AIRWORTHINESS DIRECTIVE GLIDERS/POWERED SAILPLANES

GFA/AD 219

TYPE AFFECTED: Jantar series, all SZD-42, SZD-42-1, ("Jantar-2" and "Jantar-2A") as well as SZD-42-2 "Jantar 2B", up to Serial No. B-1074 inclusive.

SUBJECT: Retention of the "Tarnamid" bearing sleeve fitted into the bottom rudder hinge.

Fig. 1.

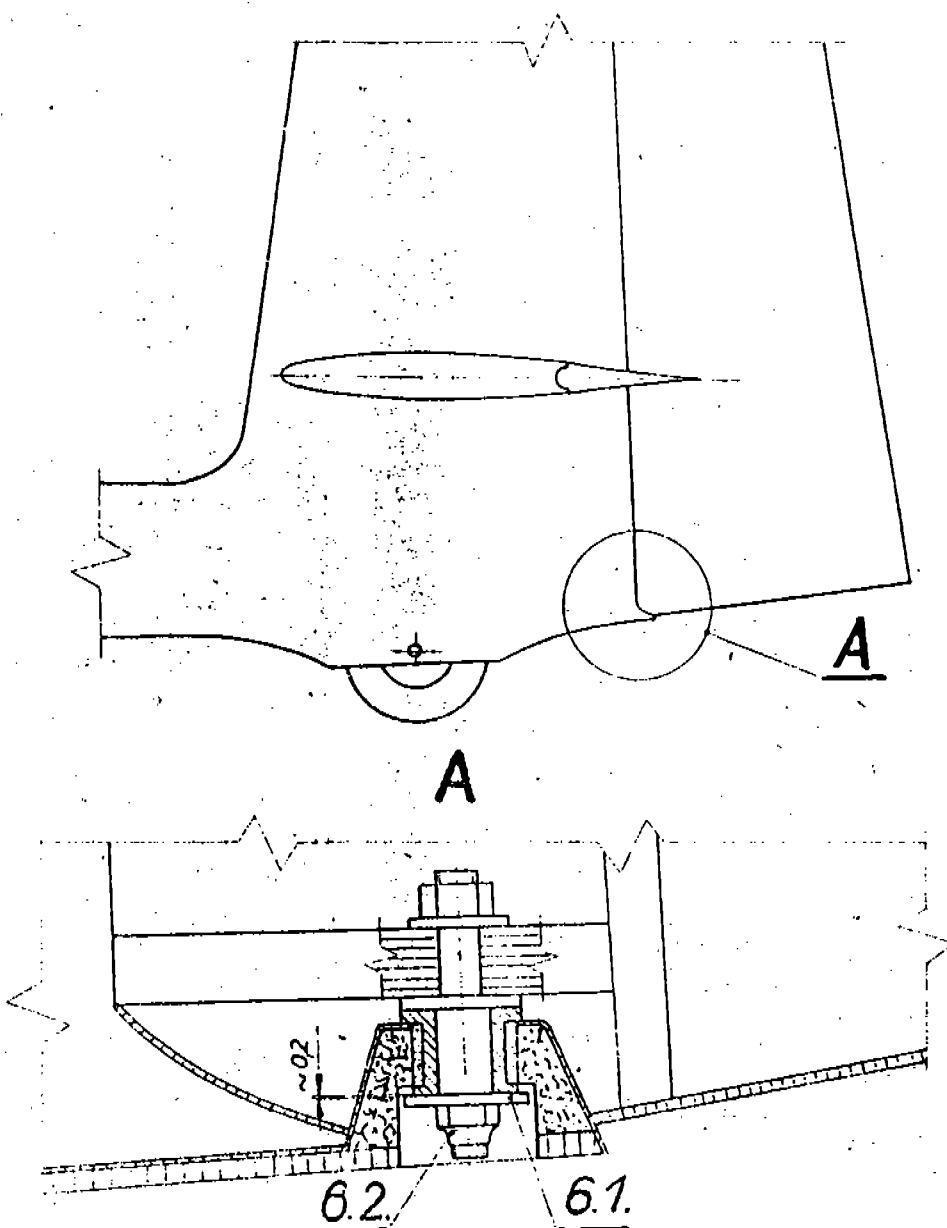
BACKGROUND: Impact during takeoff, landing, and manoeuvring on rough ground can cause looseness of the bearing, possibly allowing vertical freedom of the rudder.

REQUIRED ACTION: (1) A washer, either factory supplied through the Australian distributor, or made from mild steel to Fig 2 is to be fitted to the bottom rudder hinge assembly to Fig 1, replacing the existing washer.
(2) Modification details to be entered into log book.
